SHEPPARTON NORTH EAST GROWTH CORRIDOR

PRECINCT STRUCTURE PLAN

GREATER SHEPPARTON CITY COUNCIL

Traffic Engineering Peer Review

Figure 6: Preliminary Urban Structure Plan (Source: Draft PSP – page 10)

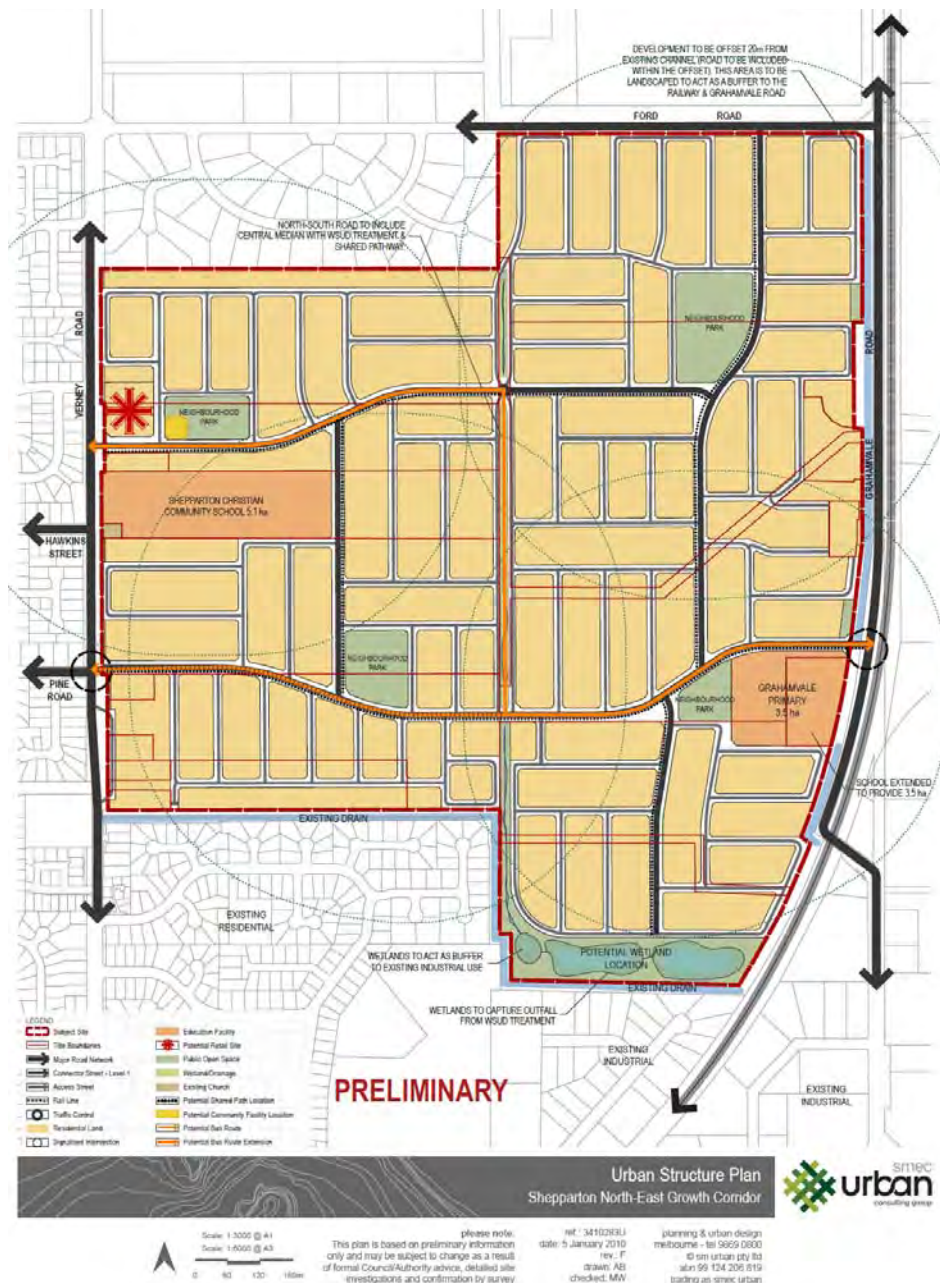
The preliminary PSP shows Verney Road, Ford Road and Grahamvale Road forming the major road network surrounding the site. Four connector road intersections are proposed, including two to Verney Road (of which one is opposite Pine Road), one to Ford Road and one to Grahamvale Road.

Figure 7: Traffic Distribution Assumptions – AECOM

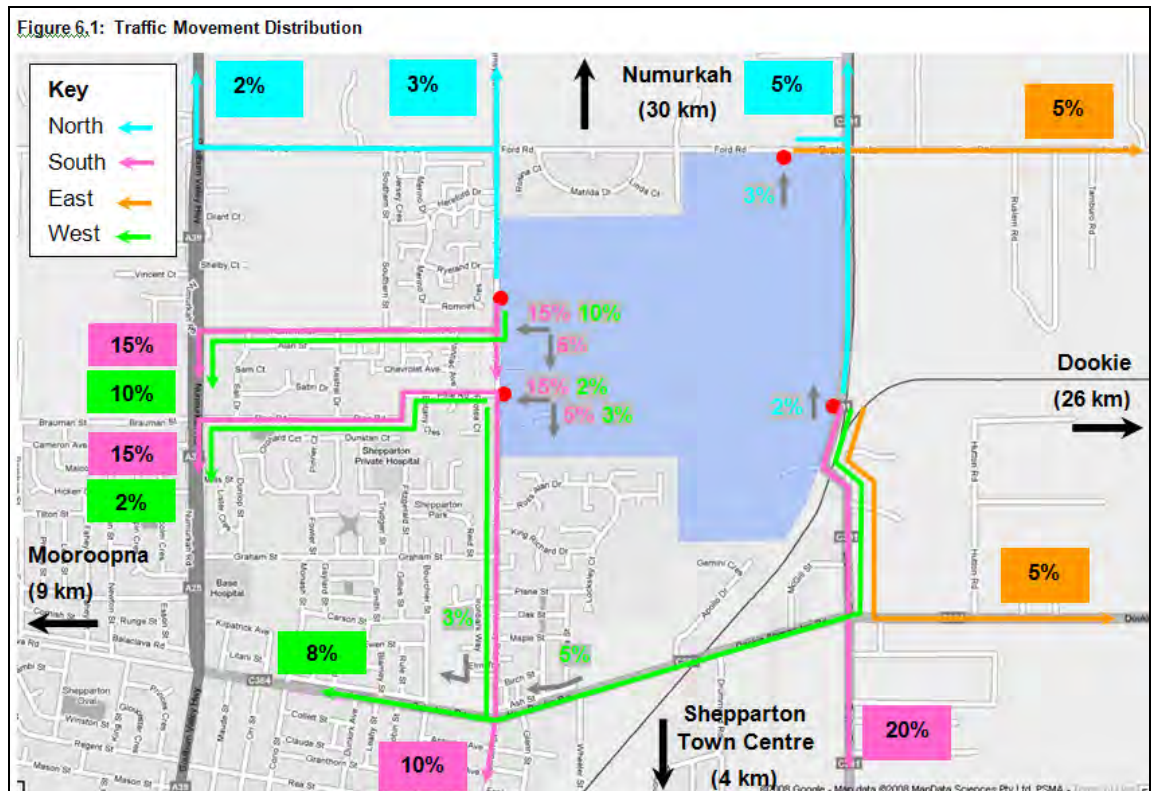
The northbound and eastbound traffic distribution assumptions are considered to be appropriate.

However, we note that AECOM has distributed 40% of the westbound traffic to exit the development at the eastern access point. Having regard to the internal connectivity of the proposed road network, we believe that more of the westbound traffic will exit to Verney Road, and less to Grahamvale Road.

Also, 50% of the southbound traffic is shown to access Goulburn Valley Highway via either Hawkins Street or Pine Road (half via each route). Vehicles accessing Hawkins Street are required to turn right at an uncontrolled intersection (Verney Road/Hawkins Street intersection) and travel through a residential area. We would expect that the split would be skewed more to Pine Road, given that a controlled cross-intersection is proposed at that location. Some Hawkins Street traffic will also only travel as far as the neighbourhood centre (at the northeast corner of the Hawkins Street/Goulburn Valley Highway intersection) and not turn right into Goulburn Valley Highway.

A diagram with recommended revised splits is shown below.

Figure 10: Recommended Road Network for PSP

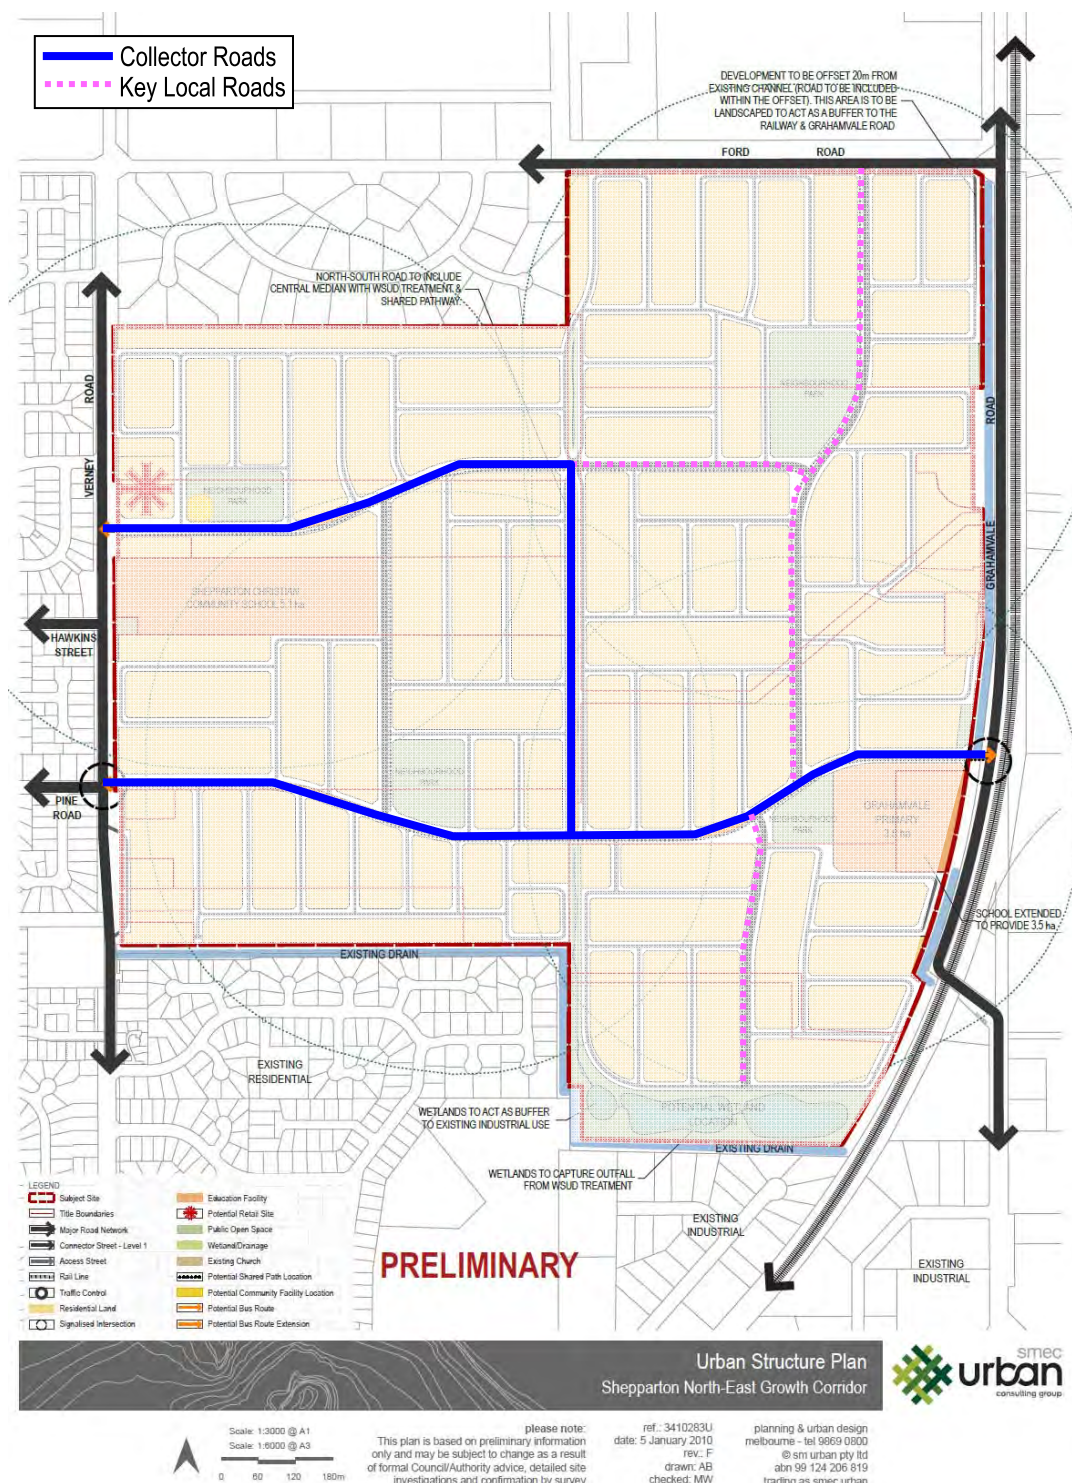
Figure 10 below shows the recommended road layout which should be included in the PSP. While a more detailed local road network has been prepared by Smec Urban (which shows that a workable local road network can be achieved), it is recommended that the level of detail shown in the PSP be reduced.

Figure 11: Recommended Layout

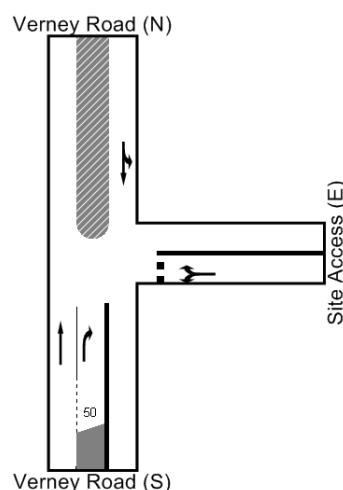
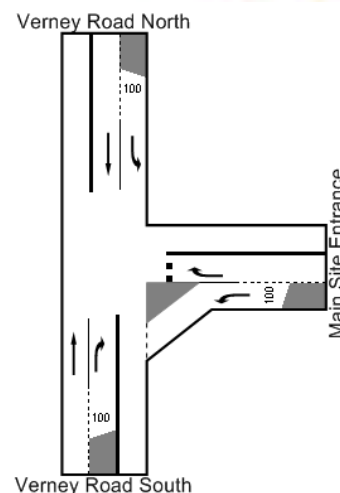
We note that the layout adopted in SIDRA for the above analysis is different to the layout adopted by AECOM.

The two variations are shown in Figures 11 and 12 below.

The layout shown in Figure 11 is consistent with the treatment at existing intersections to the south, i.e. no left-turn lane in from the north. Traffic volumes entering from the north are very minimal, and a left-turn lane isn't necessary from a capacity perspective, as shown by the SIDRA results. Similarly, the number of vehicles turning right out of the development heading northbound is also very low, and separate right and left turn lanes out of the site are unnecessary from a traffic capacity perspective. In practise though, providing separate turn lanes will retain flexibility to upgrade/signalise the intersection in the future if required. Something between the two options shown above is recommended, with a shorter left turn lane from the north in accordance with the requirements for a 70km/h speed limit, and separate left/right lanes exiting (short left-turn lane, say 30 metres storage plus 30 metre taper, but not a slip lane).

It should be noted that Council has indicated that Verney Road must have protected right turn lanes. The Council has recently prepared a concept layout for Verney Road. The proposed cross-section of Verney Road north of Drain No.3 is one northbound lane, one southbound lane and a central median which can cater for right turn lanes at intersections.

Figure 14: Possible Bus Route (Including External Components) and Bus Stop Locations

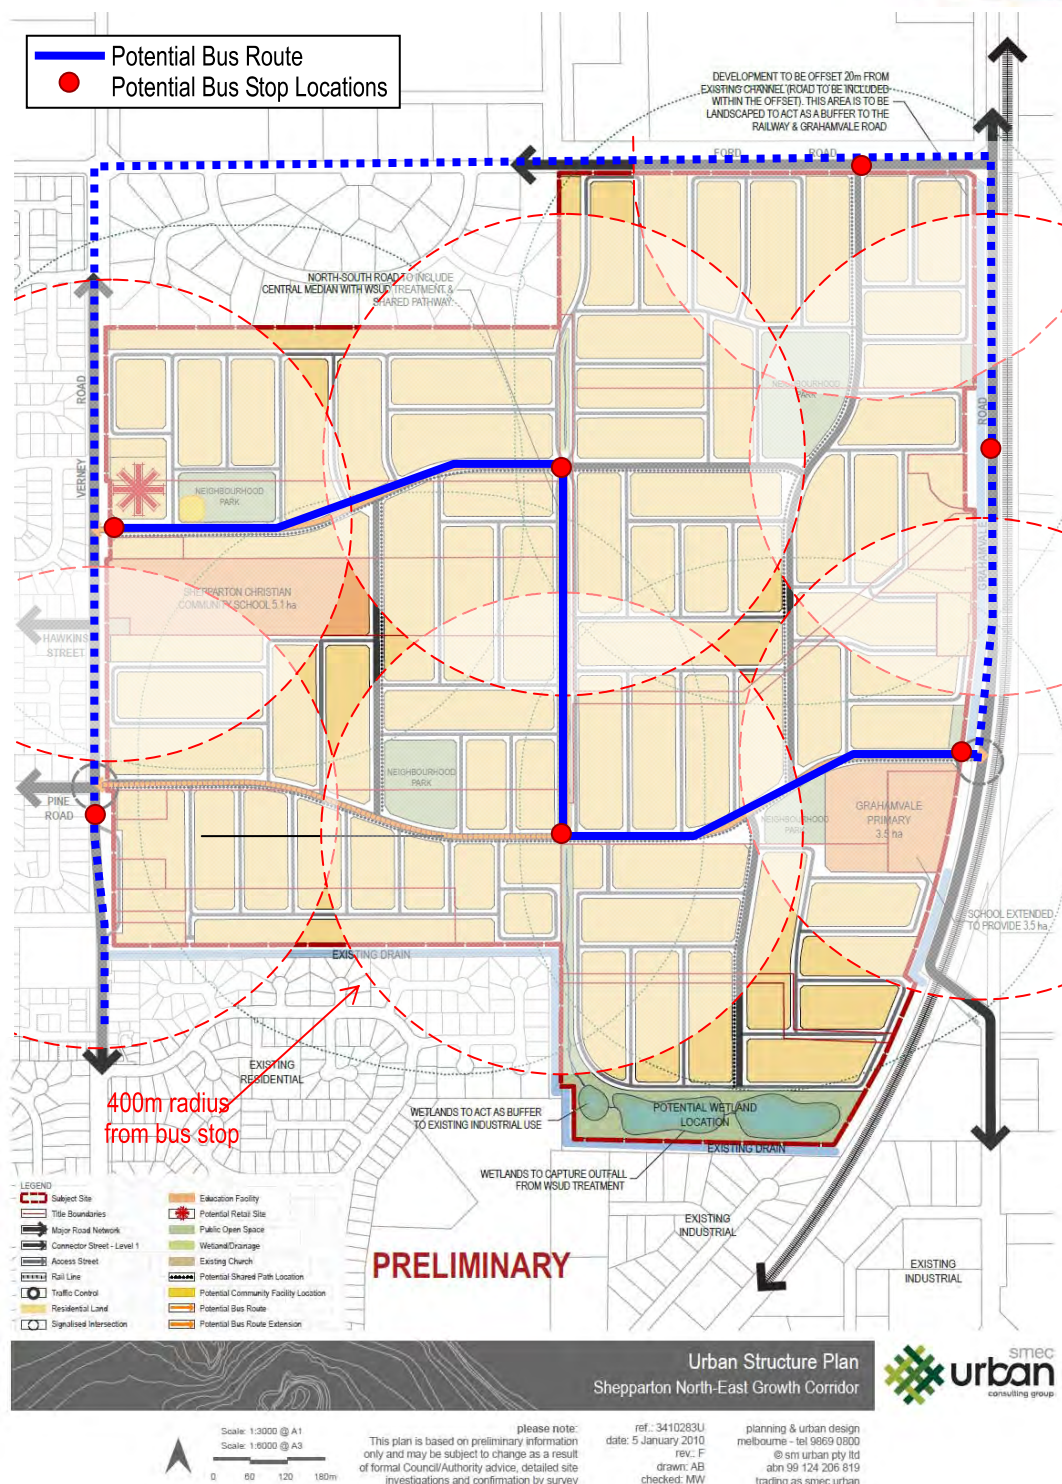
We note that while DOT suggests that the potential route currently shown on the preliminary plan does not provide sufficient penetration or coverage, it would provide sufficient coverage subject to the future route extending north along Grahamvale Road, west along Ford Road and then south along Verney Road, with stops provided at appropriate locations, as indicated in Figure 14 below. Note that the circles shown in Figure 14 are approximately 400 metres radius.

- g) A 'public transport plan' should be included in the PSP, and should be referred to the Department of Transport (DOT) by Council for comment. A possible plan is shown in Figure 14 of this report, although we understand this may need to be amended to reflect Council's current position that the Verney Road/Site Access intersection should be located further north to become a cross-intersection/continuation with Ryeland Drive.
